# ASCENT CHURCH

### GRADING & EROSION CONTROL PLAN

PCD File PPR265

ASCENT CHURCH  
GEC INITIAL-INTERIM  
4 OF 13

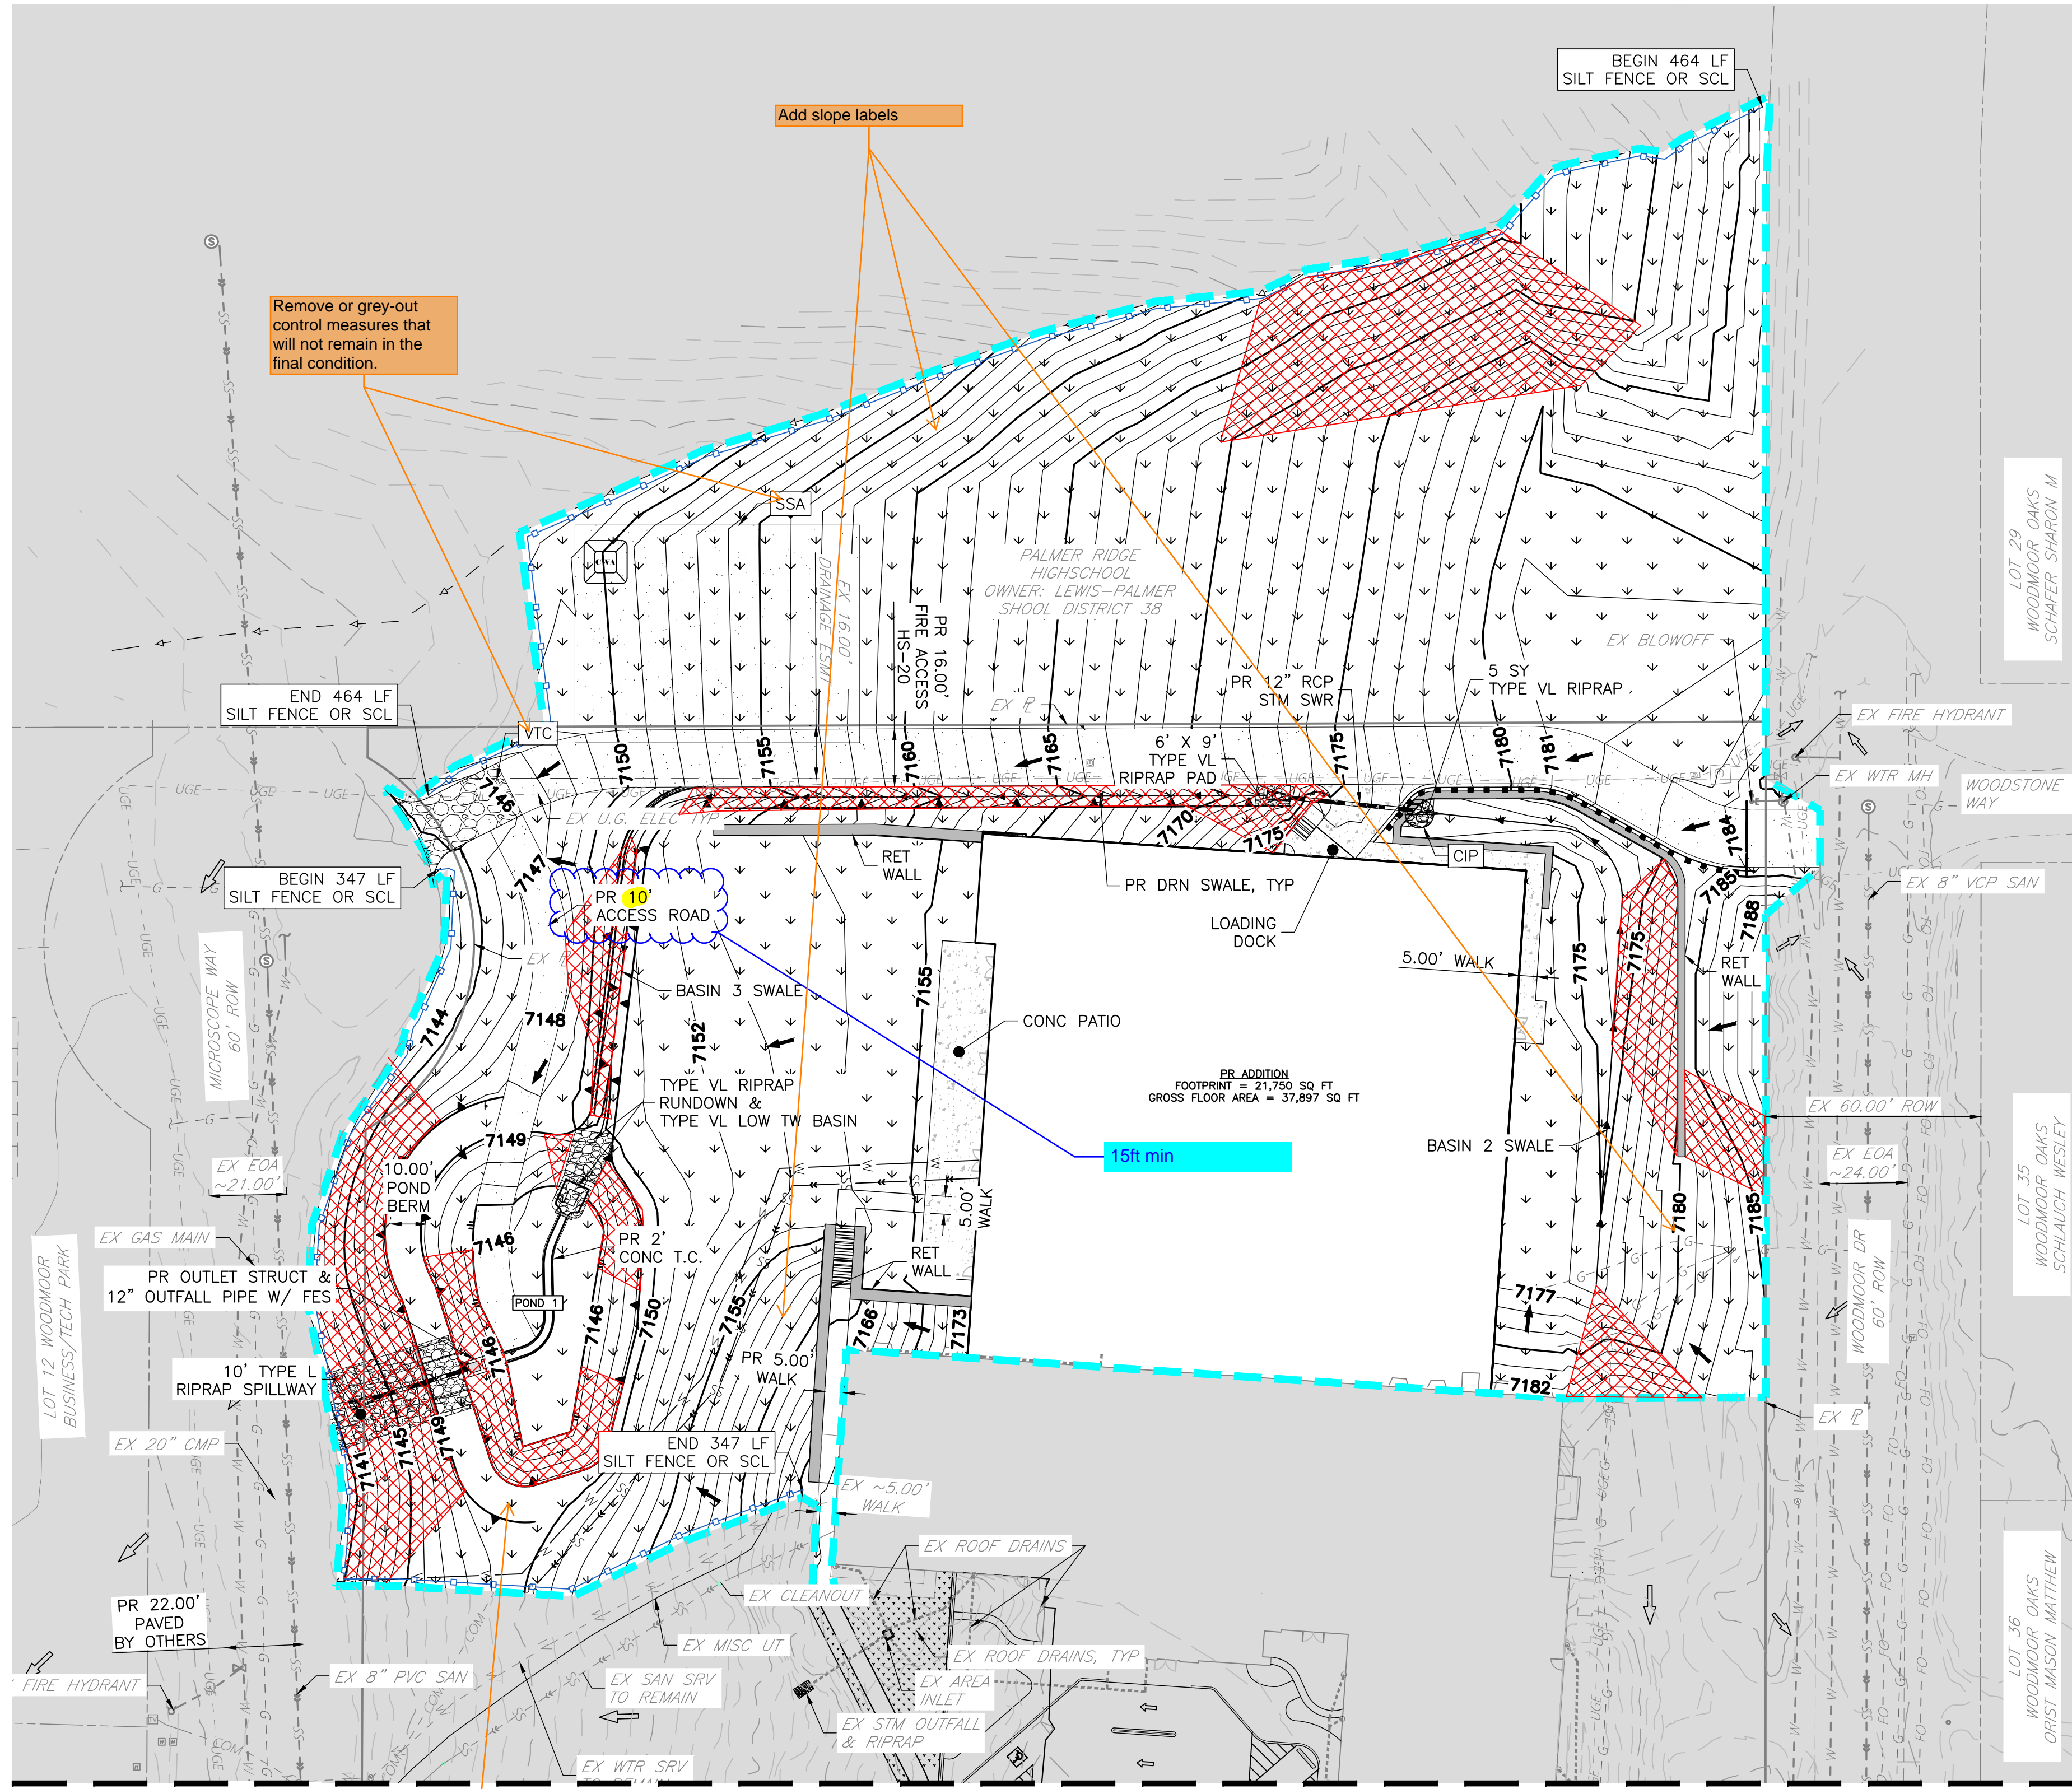
If "limits of disturbance" and "construction boundary" are the same, change to "limits of construction/disturbance" or otherwise show as separate line types for each on the legend and figure.

Show existing vegetation (notes are acceptable in cases where there is no notable vegetation, only grasses/weeds, or site has already been stripped)

Please provide control measures to prevent sediment from discharging off-site during construction

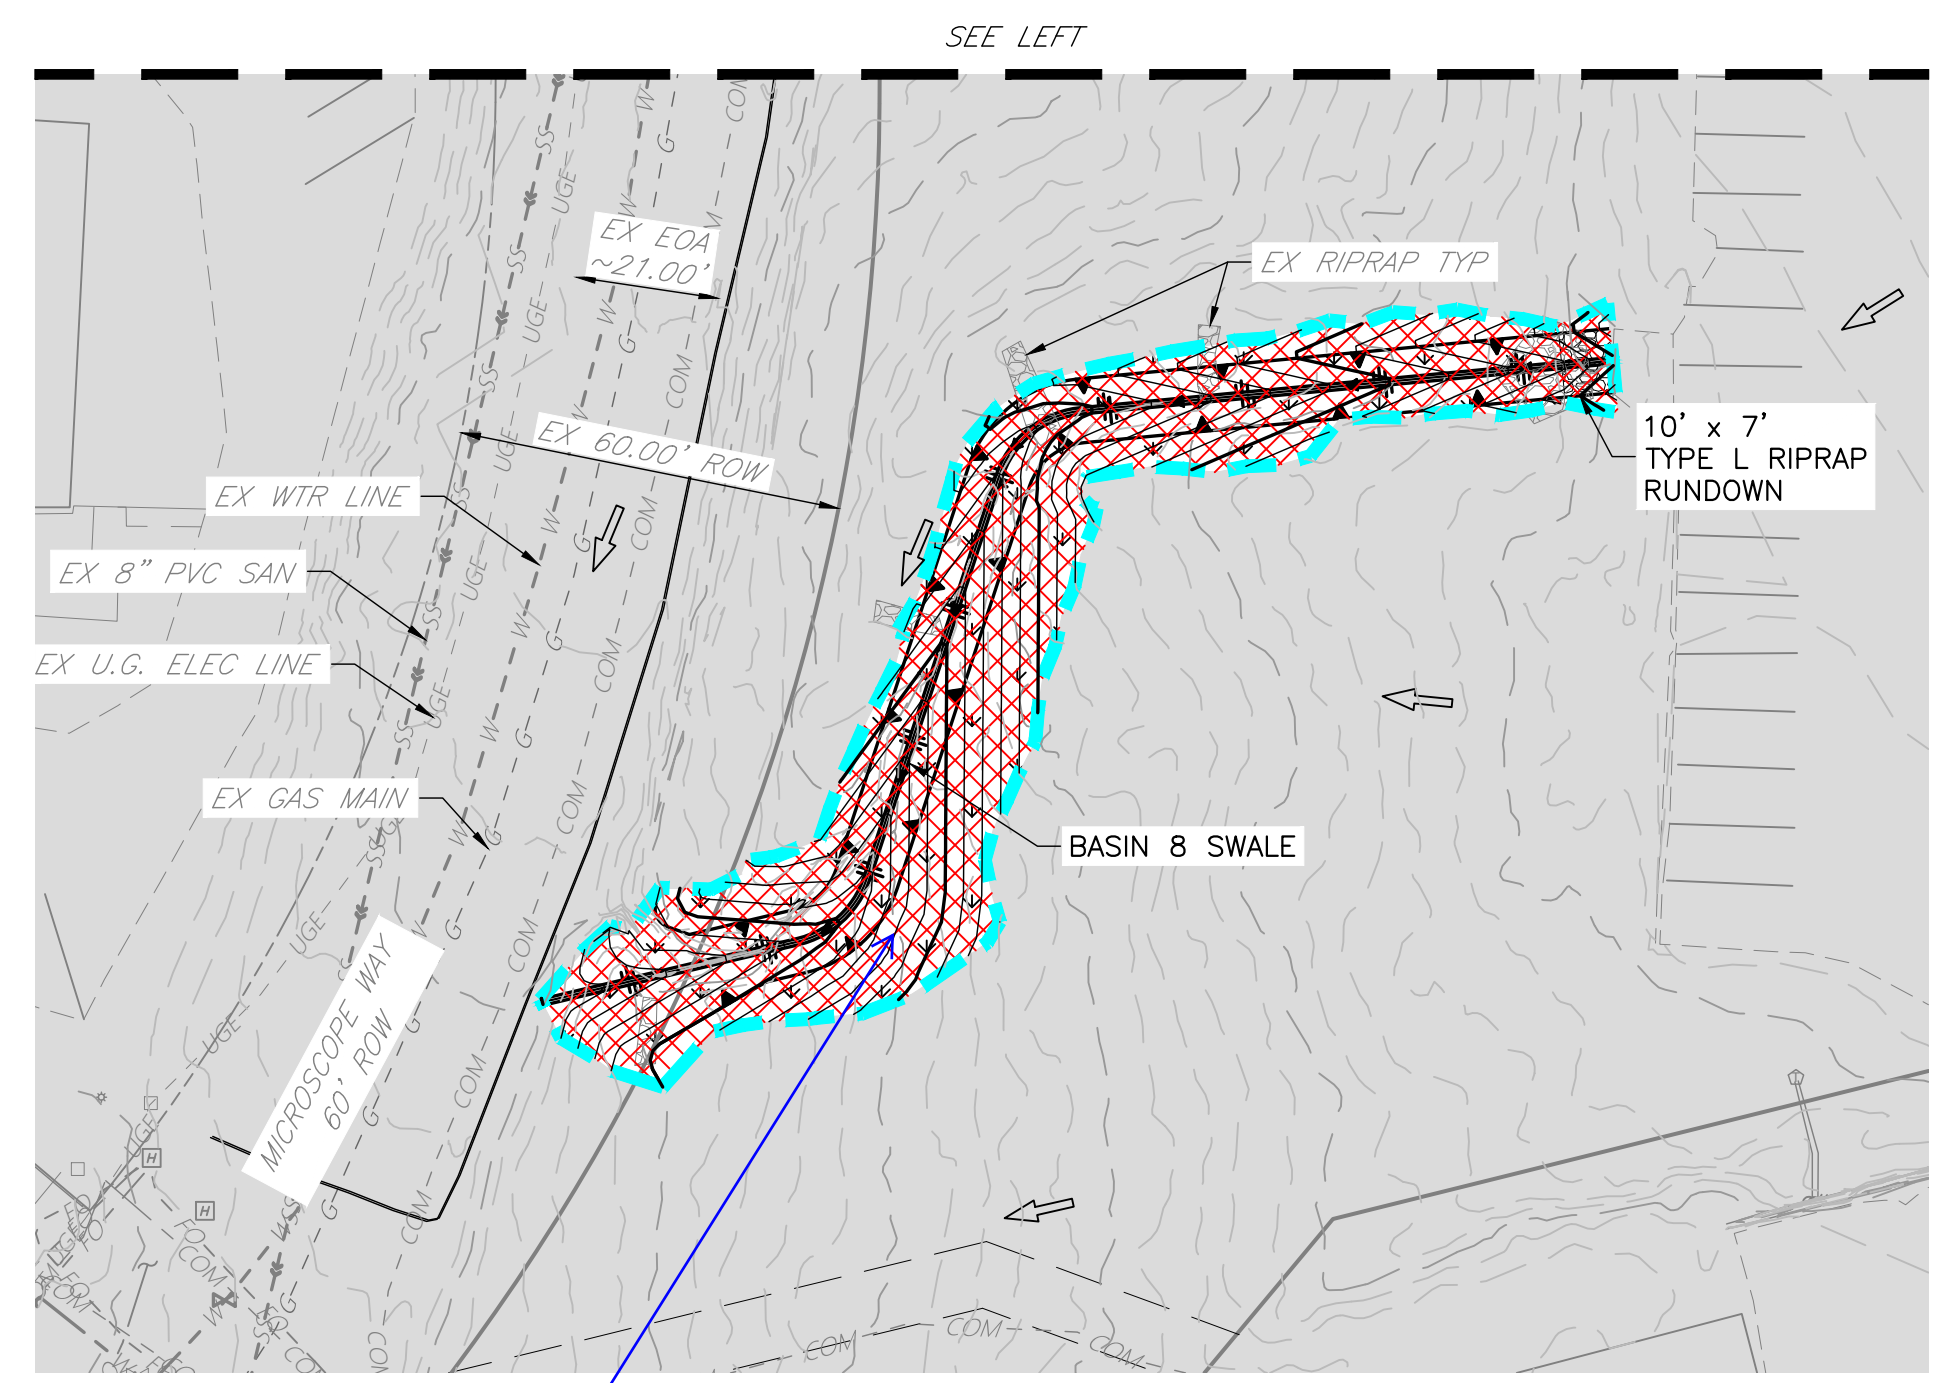
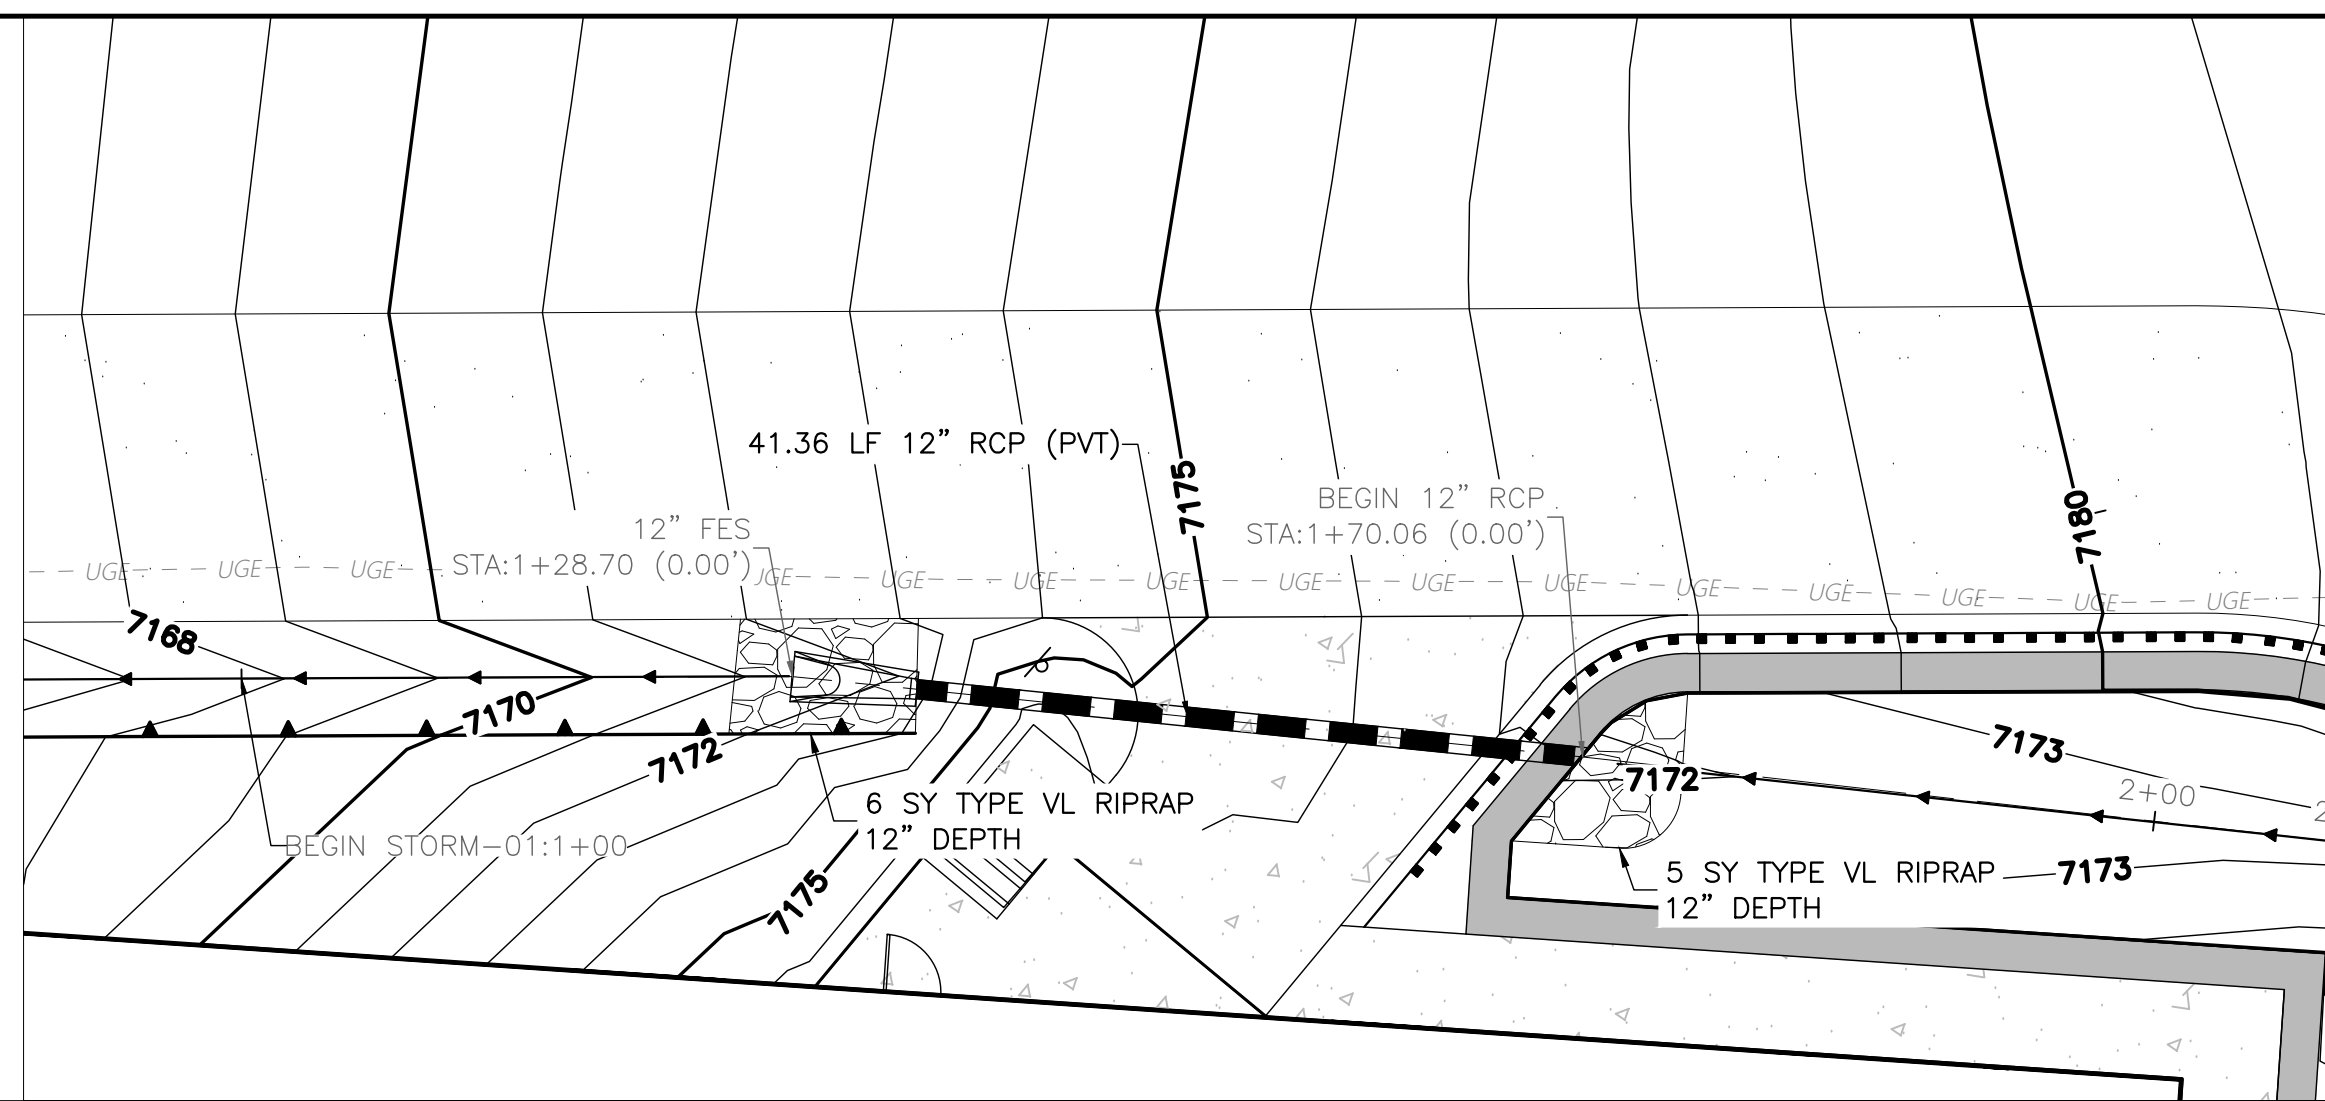
Remove or grey-out control measures that will not remain in the final condition.

Add slope labels

Indicate the phase of implementation for each temp control measure (initial/interim/final)

Show areas of proposed cut and fill

Provide pond maintenance access easement and the road itself from the bottom of the pond up the embankment, around the perimeter of the pond, and to a public road, per DCMv1, Chap 11.2.2.

If swale will not have irrigation to ensure grass growth then TRM with check dams should be considered. The GEC Plan reflects ECB in the drawing where the swale profile denotes TRM. Velocity exceed 4ft/s such that the seed mix spec'd does not hold and will not establish without irrigation
